PROJECT: Replacement of Air Conditioning Units at Malaga Elementary School,
John Sutter Middle School, Fowler High School for Fowler Unified School District

Request #7

**Project: Replacement of Air Conditioning
Units at Malaga Elementary School
John Sutter Middle School
Fowler High School for
Fowler Unified School District**

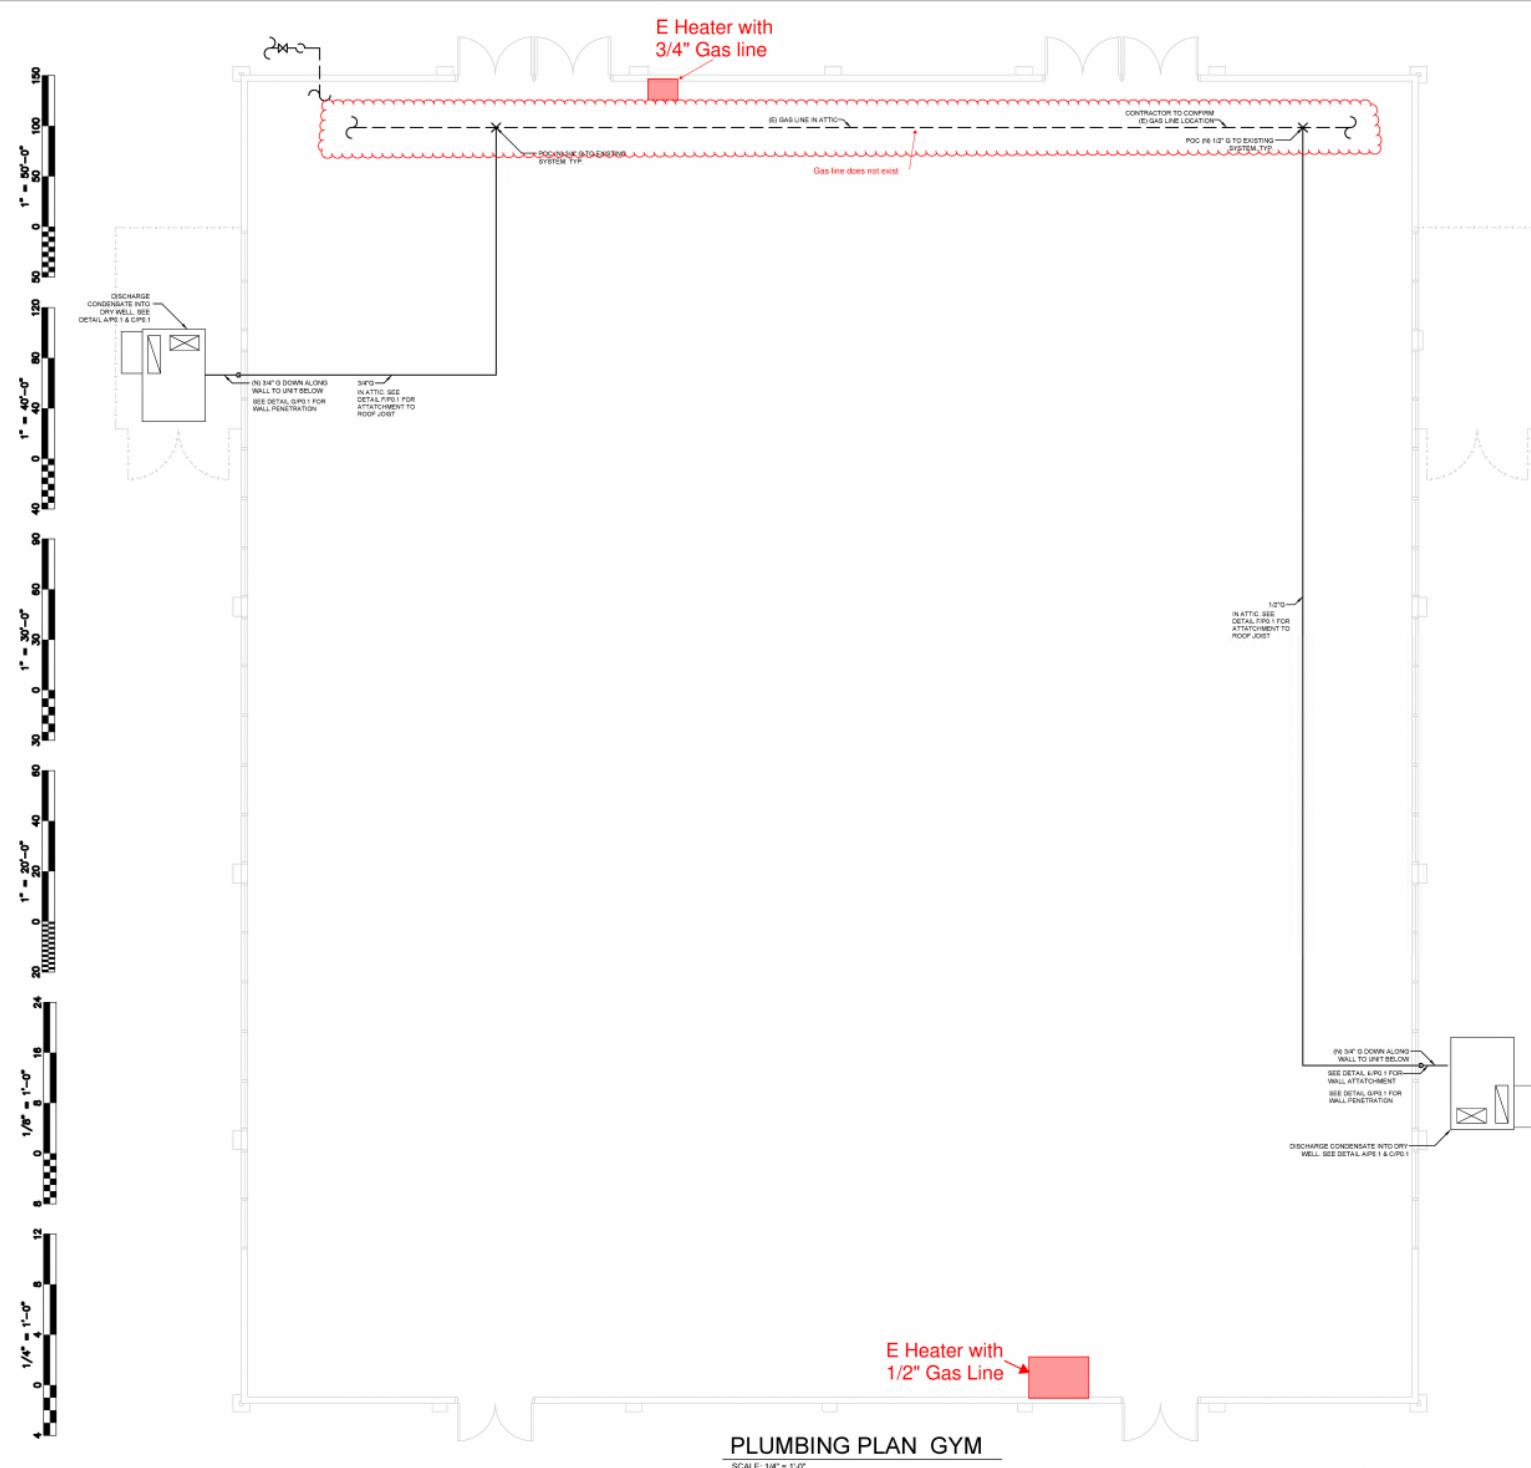
Recommendation: Tie into the gas lines at the existing heaters. See attached plans.
